Arrow Fabrics (Pvt) Ltd.

07th November 2018

Observations

Discrepancies between provided drawing and on site condition

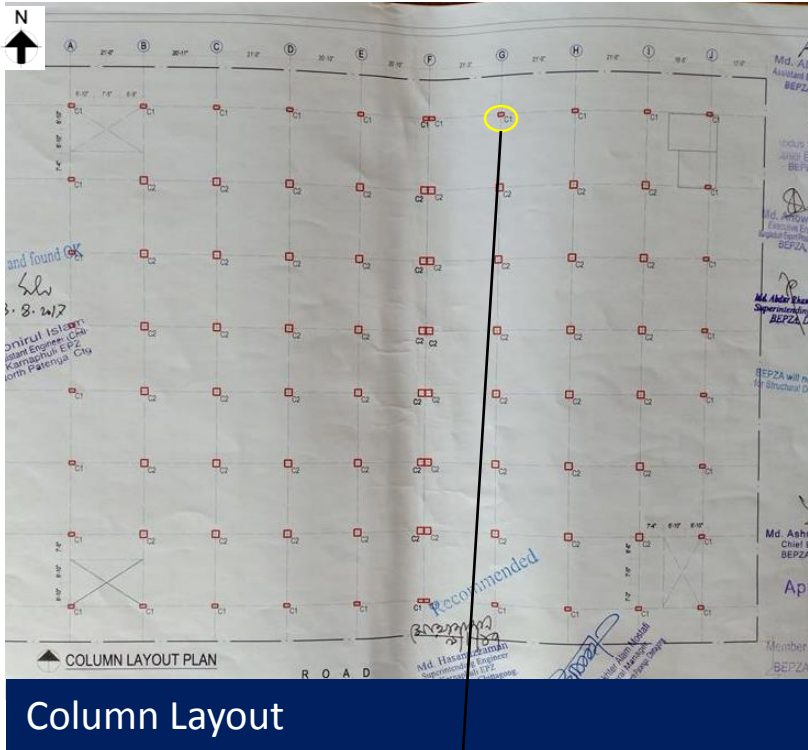
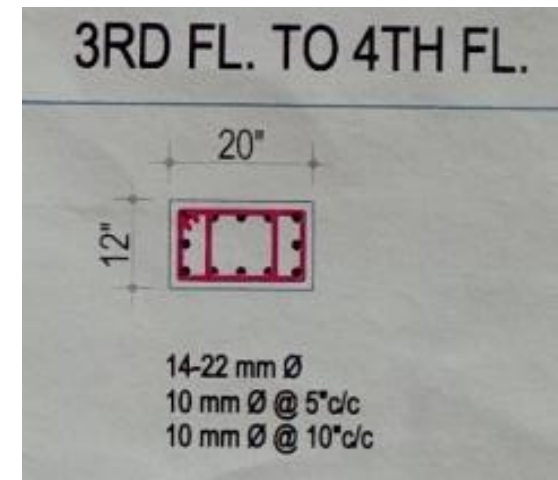
At C-1 type column, 10 nos. rebar was found instead of 12nos. by ferro scanning on 3rd floor. On the other hand, sectional details shown 12 nos. of rebar whereas statement shows 14 nos. of rebar.

Item No.	Observation	Recommended Action Plan	Recommended Timeline
1	Discrepancies between provided drawing and on site condition. (Production building)	Building engineer to survey the building and produce as-built documentation reflecting the as constructed condition.	6-weeks
2	Possible vertical extension (Production building)	In case of extension, factory engineer to be carried out further analysis and update design report following BNBC requirement.	6-weeks
3	Non-engineered shed above utility Building. (Utility Building)	Prepare an “as constructed” drawings which reflect the actual site dimensions with complete structural information.	6-weeks
4	Non-engineered shed above utility Building. (Utility Building)	Building engineer to check the capacity of the lightweight steel roof against lateral loading.	6-weeks
5	Non-engineered shed above utility Building. (Utility Building)	Carry out remedial works resulting from engineering assessment if necessary.	6-months

Possible vertical extension

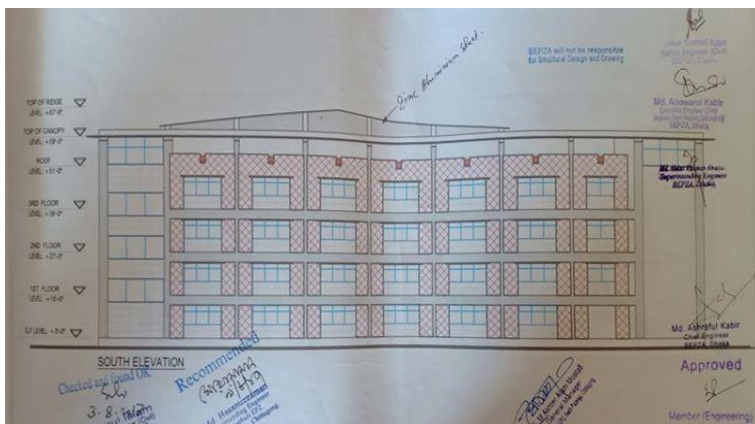
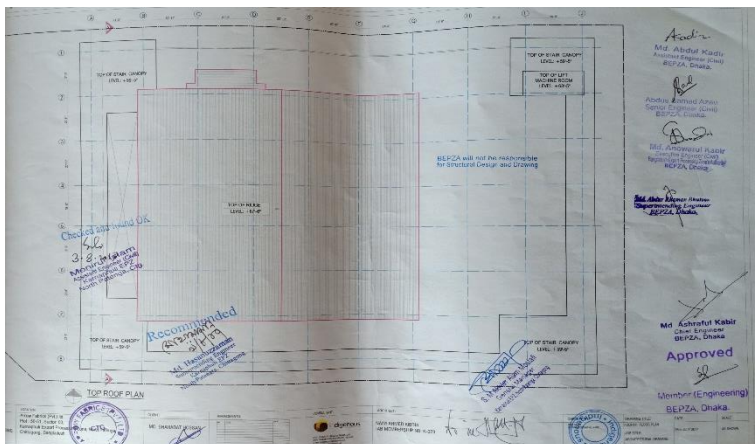
This building is permitted for 5 (G+4) storied from BEPZA. Currently the building is 3 storied. Factory has a future plan to built a shed on current roof. Proposed drawings were available during inspection. Factory engineer is required to carried out a Detail Engineering Assessment considering BNBC provision prior to any extension work.

BEPZA Permit drawing shown 5 storied
